NORTH ANNA ENVIRONMENTAL COALITION

On December 4, the Coalition mailed each Commissioner a copy of a letter to the North Anna Atomic Safety and Licensing Board asking for study of REGIONAL EPICENTER MAP--
Period January 21, 1974 through August 1, 1977.

Detail from VEPQ's Regional
Epicenter Map--microearthquakes
registered January 21, 1974
through August 1, 1977

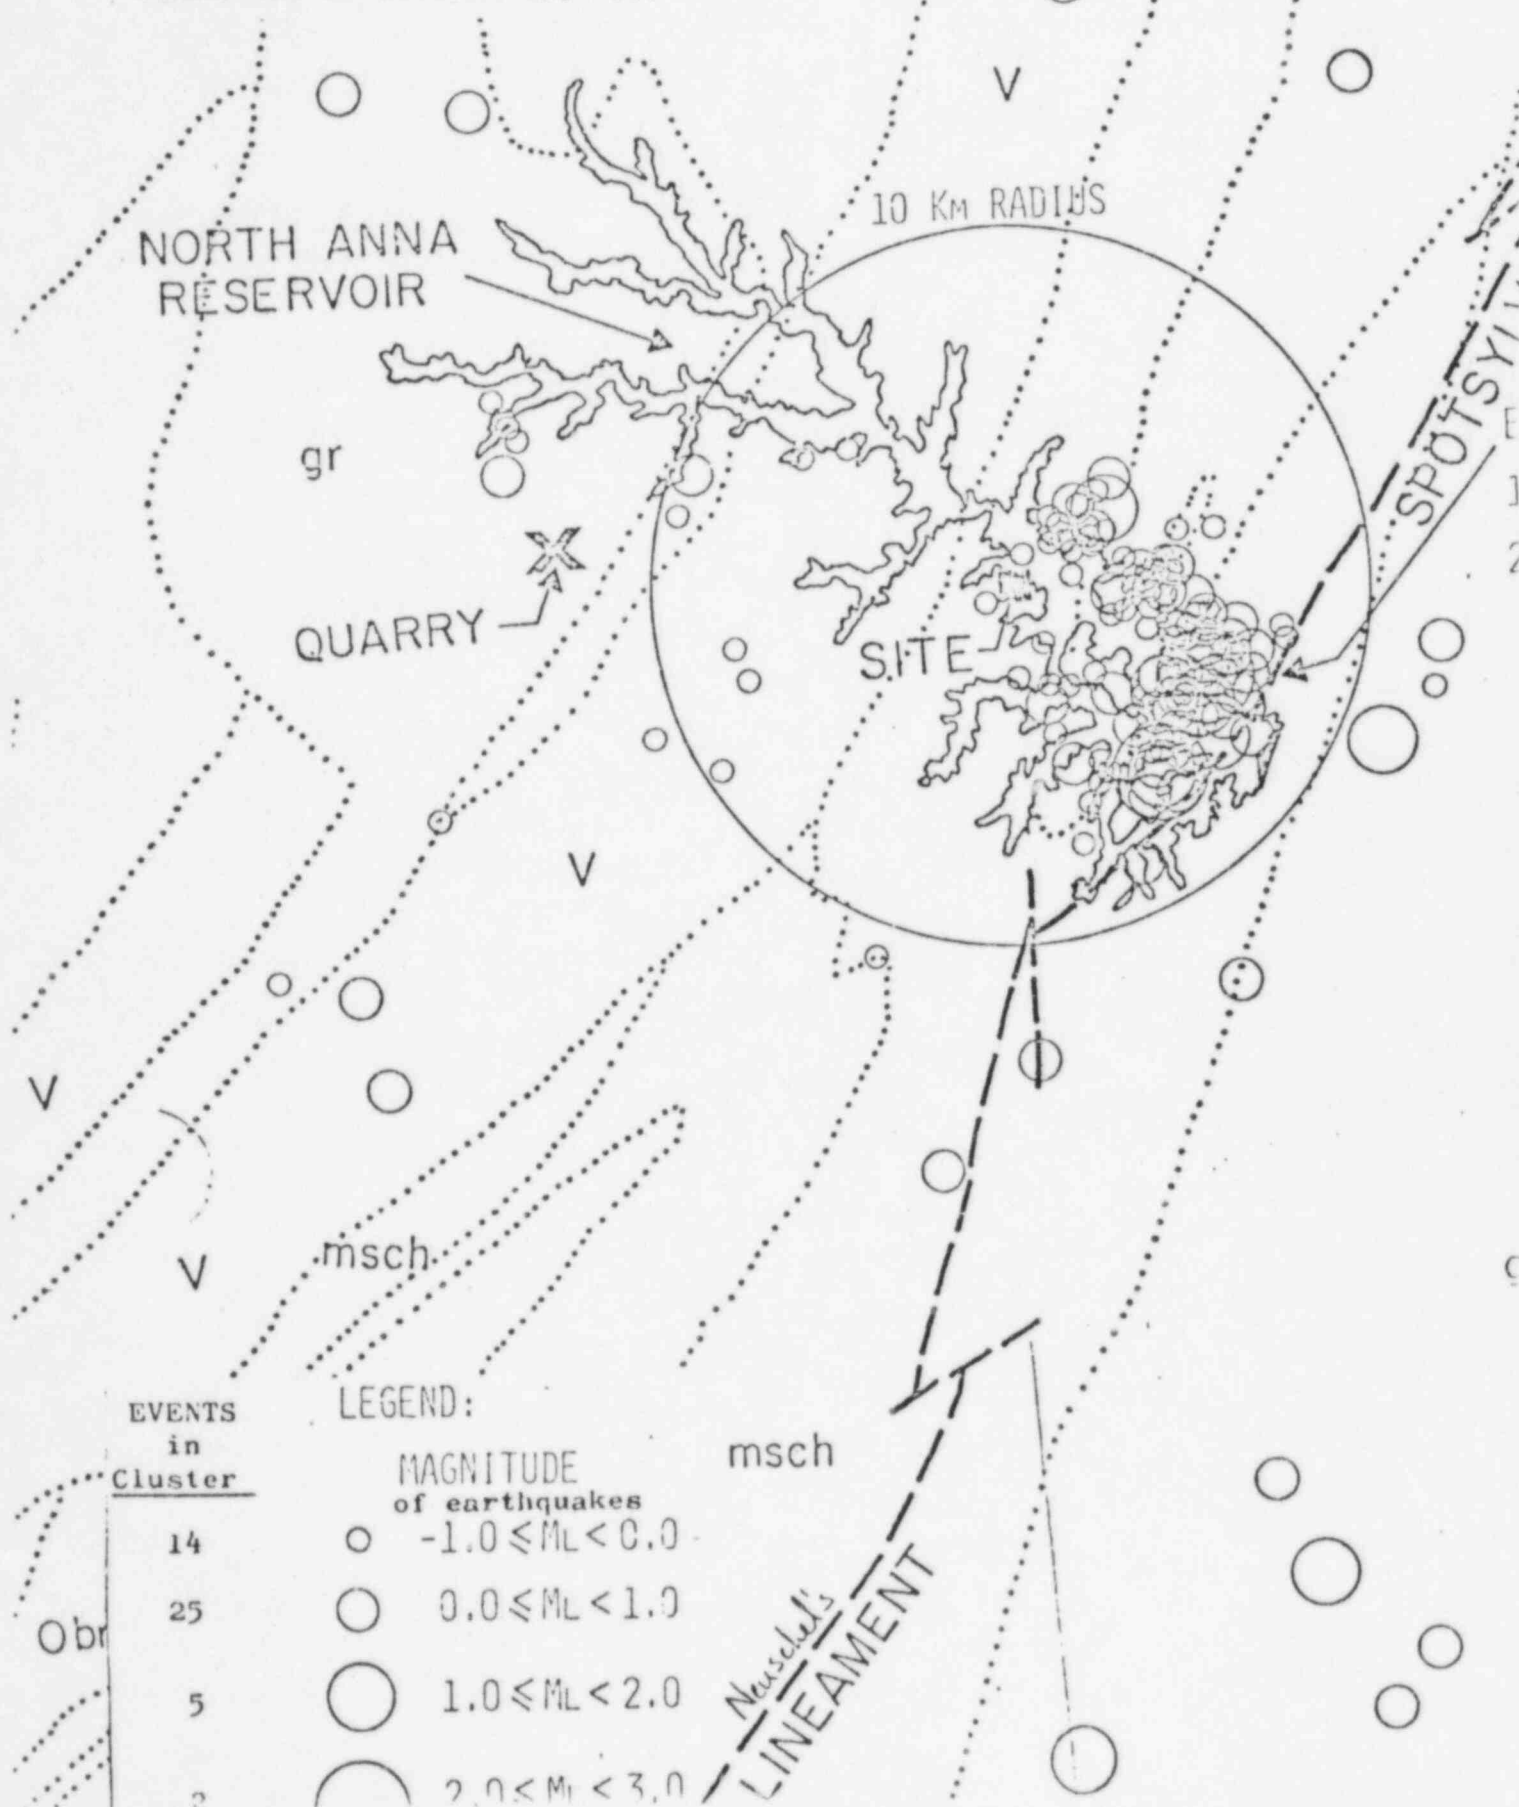
Enclosed with that letter was an obsolete map showing 22 micro-earthquakes northwest of the North Anna dam as opposed to the cluster of 46 micro-earthquakes on the above-mentioned REGIONAL EPICENTER MAP. Today, please find enclosed a detail from the more recent map which shows the cluster of 46 micro-earthquakes at the point where Neuschel's Lineament (renamed Spotsylvania Lineament on the map) intersects Lake Anna. vEPCO consultants note yet another convergence: "A hypothetical projection of the Stafford Fault Zone southwest from Fredericksburg would intersect in the same general area of the reservoir."

We trust the Commissioners are aware of the work by the United State Geological Survey (USGS) in the past two years which identified the Stafford Fault Zone, and revised geological estimates of fault age in the Piedmont, finding structures many years younger than was previously assumed. Also, recent work by the National Science Foundation lends support to Neuschel's Lineament as a major regional fault -- now seemingly reactivated by the water of Lake Anna.

In the light of this new and growing body of geological scholarship regarding the Piedmont region, the Coalition is surprised to find the NRC adhering to conclusions reached on Neuschel's Lineament "in the early 1970's" by a "USGS reviewer" who wrote that "Details regarding either local or regional geologic structures...are very poorly known."(W.Dircks-12-6-77)
